Byron Environmental Audit – Request for Additional Information Response

Question #: HCR-1 **Category:** Historical and Cultural Resources

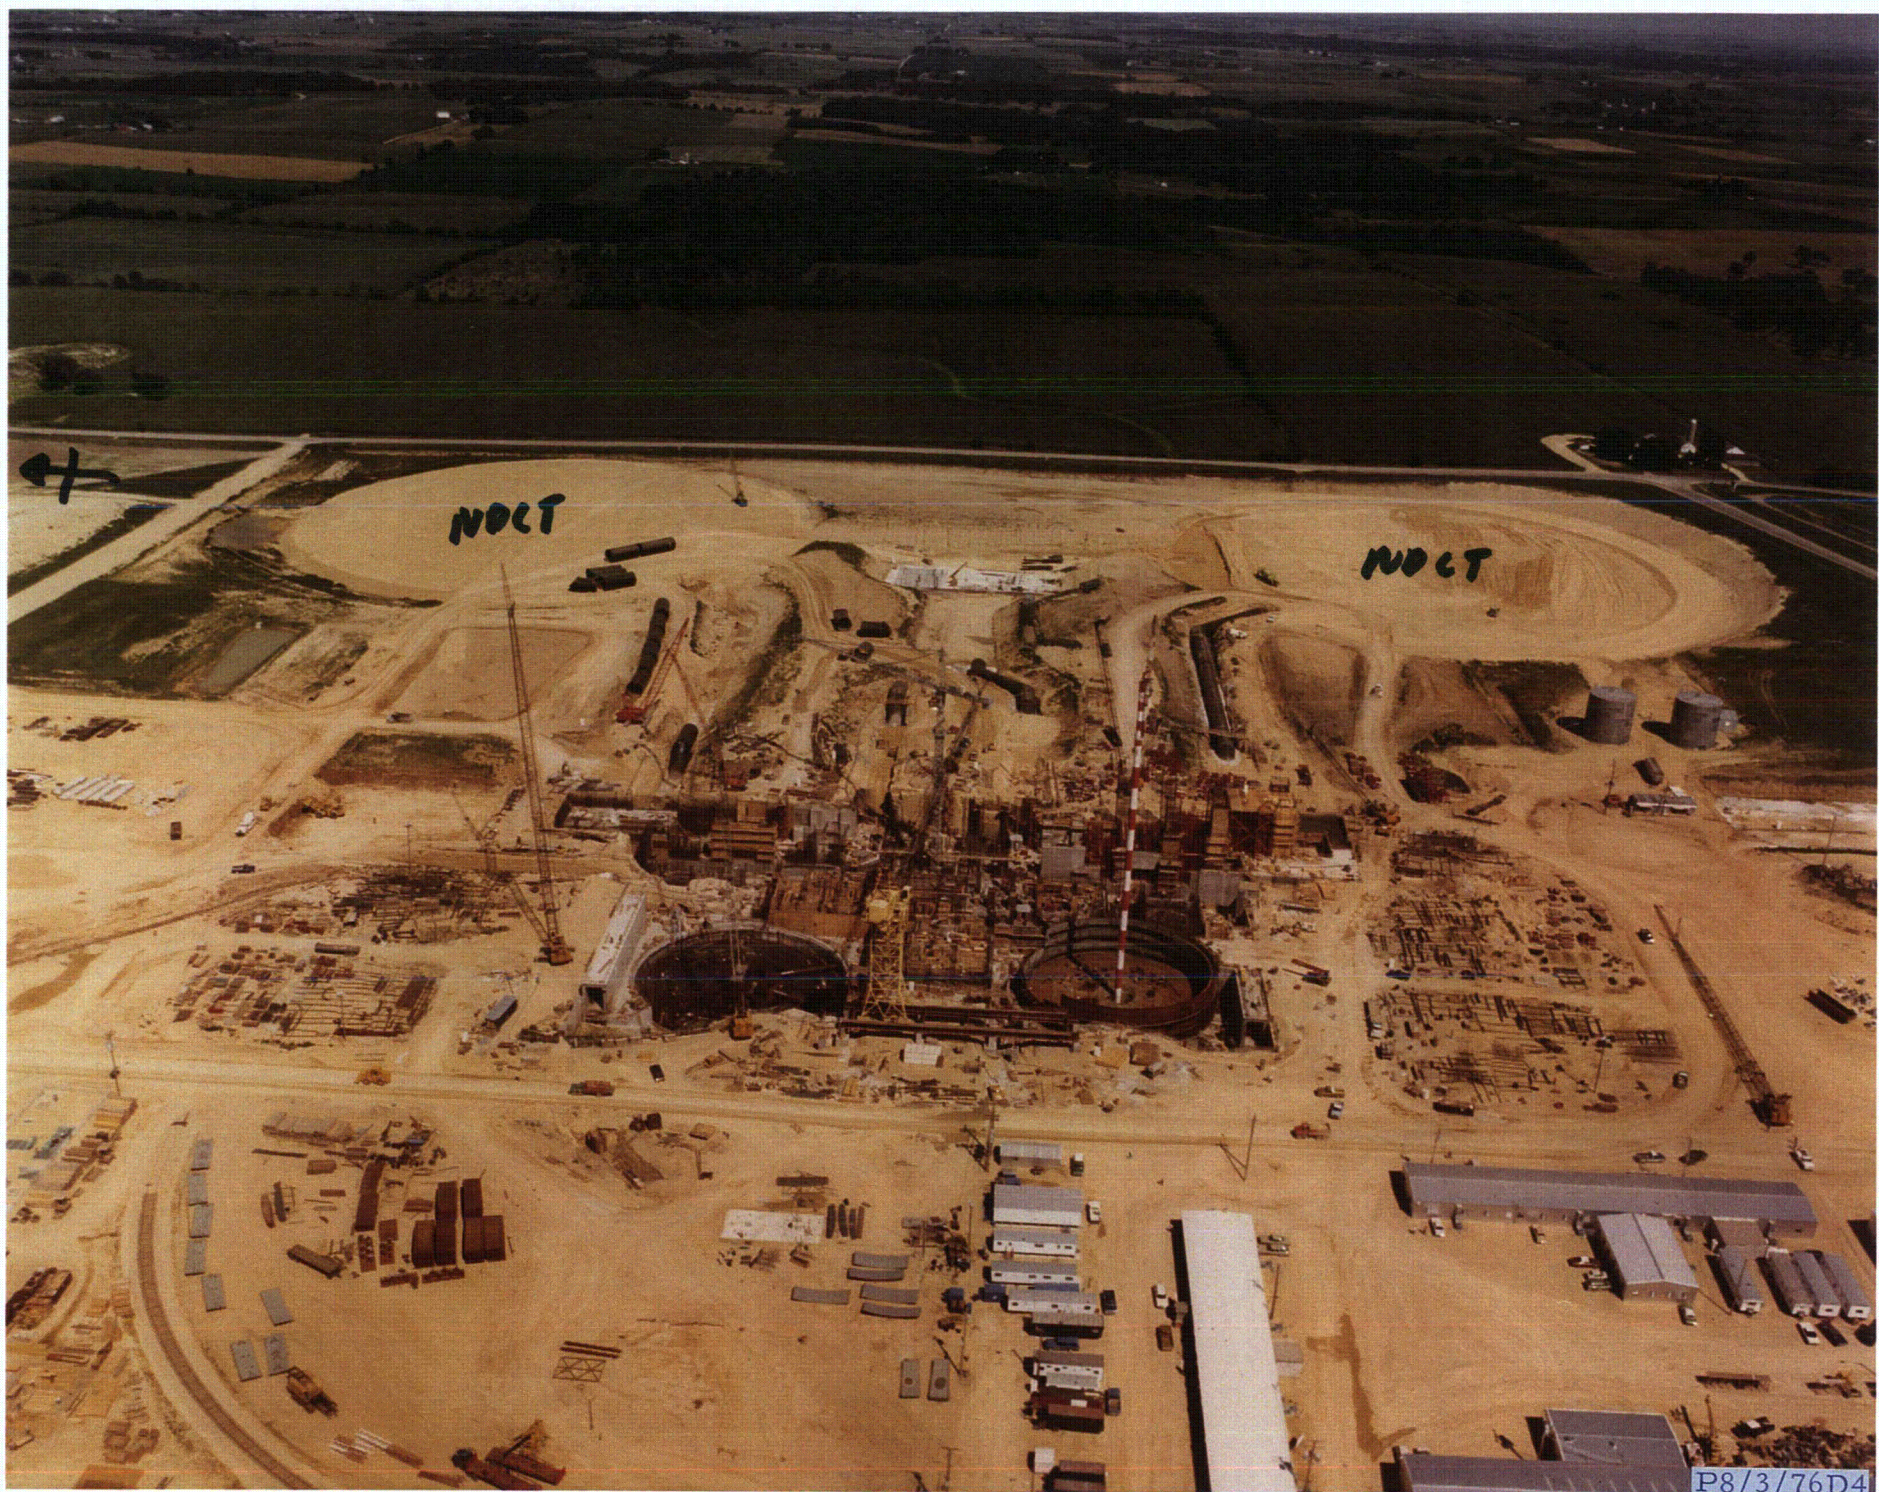
Provide a series of aerial photographs of the entire plant site and associated transmission line(s) (during pre-construction, construction, and post-construction periods) looking at levels of disturbance that occurred during construction or since operation, whether any historic structures or possible sites are present on the property, and identifying any recent projects that will require a review of additional documentation.

Aerial photographs of the plant site during the pre-construction and construction time frames are attached to this response. Also, in a letter dated February 1974, the Illinois SHPO stated that no cultural or historical sites of significance were located within the Byron project boundaries. A copy of the 1974 letter from the Illinois SHPO to the U.S. Atomic Energy Commission is attached to this response.

Byron UFSAR (Exelon Nuclear 2010a), Figure 8.2-3

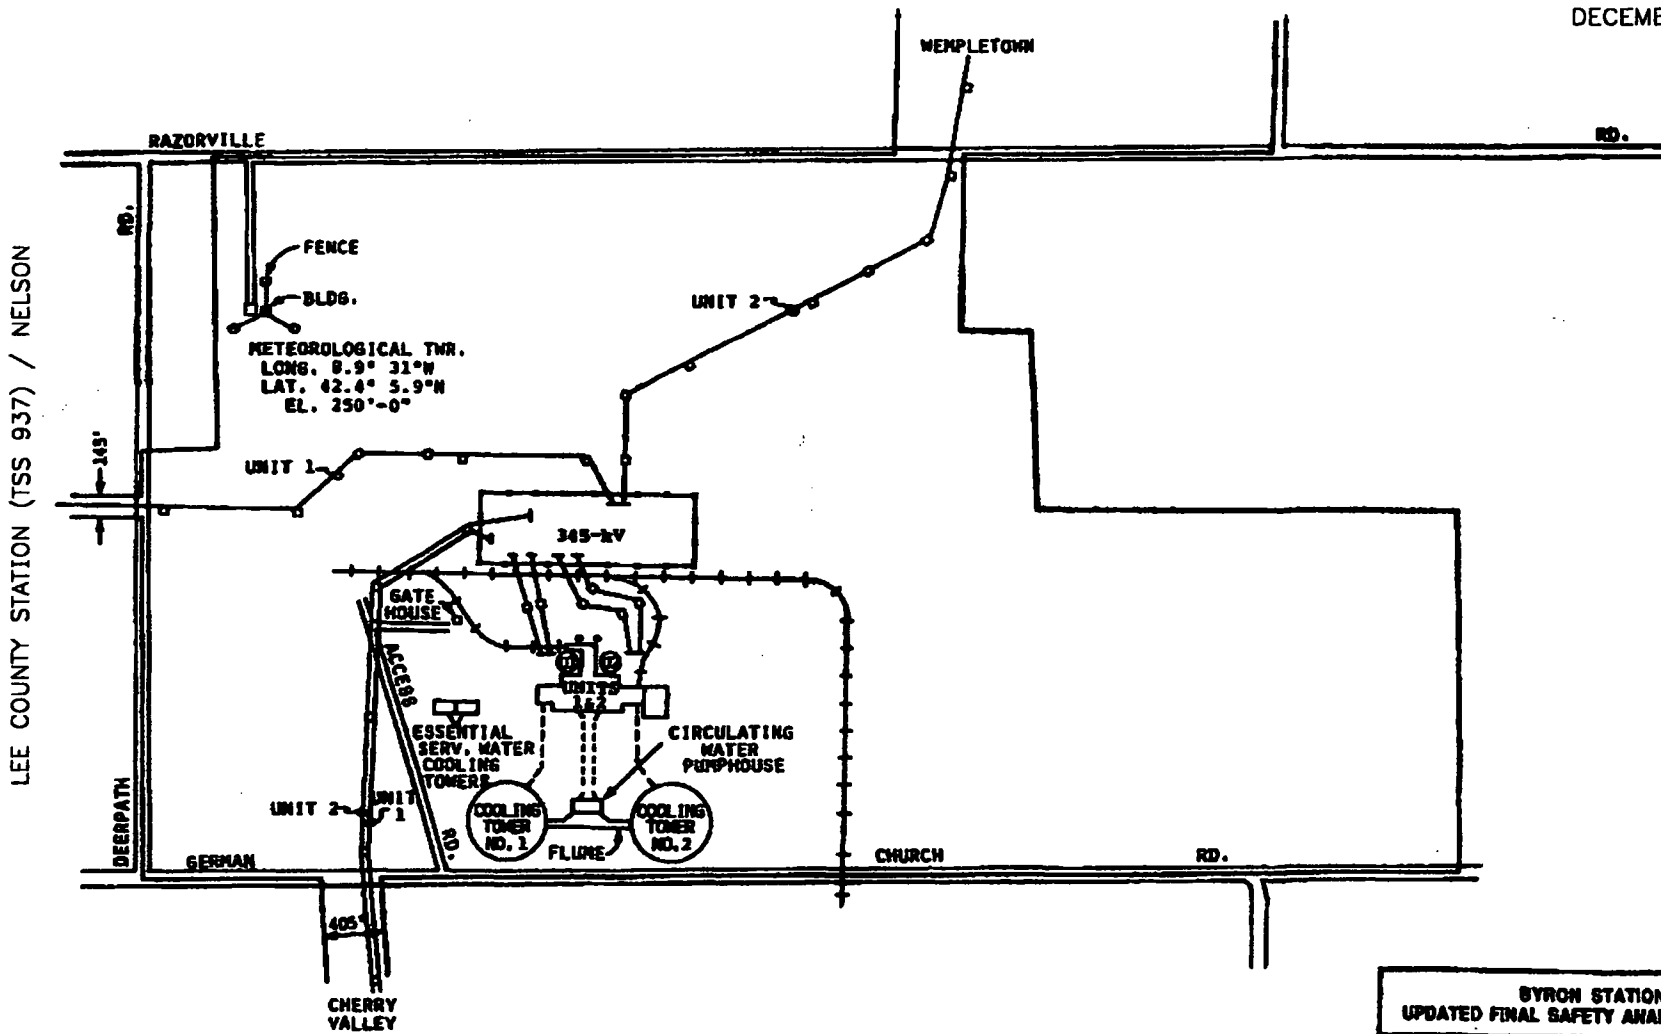
Provide a description of ComEd's transmission line management plan, including: timing of activities, danger tree removal and other clearing, inspections and repair activities conducted by ground vehicles, standard operating procedures or guidelines for the applicant and any contractors; erosion control procedures, technician training programs, and any regulations that restrict maintenance activities (e.g., looking for activities that could affect depth of disturbance, if any disturbance is necessary along the corridor).

Because the NRC will now apply the new regulations to define the scope of transmission lines for which environmental impacts are analyzed in the License Renewal Supplemental Environmental Impact Statement for Byron Station, Exelon Generation has revisited its original evaluation of the in-scope lines. Electricity generated at Byron Station is transformed from generator voltage to a nominal 345-kV transmission system voltage by the main power transformers. The main power transformers are connected via intermediate, on-site transmission lines to the on-site 345-kV Byron Station

switchyard. The location of the intermediate transmission towers on the site property is shown in Byron UFSAR (Exelon Nuclear 2010a), Figure 8.2-3. For ease of reference, a copy of the figure is attached to this response. Based on this information and that there are no other transmission lines that would be dismantled or otherwise decommissioned as a result of terminating operations at Byron, Exelon concludes that, under the new regulations, the intermediate, on-site transmission lines are the only in-scope transmission lines for the Byron license renewal environmental review. These transmission lines are located entirely within the station's protected area. Grounds management practices for that area are described in the Request for Additional Information Response HCR-7.
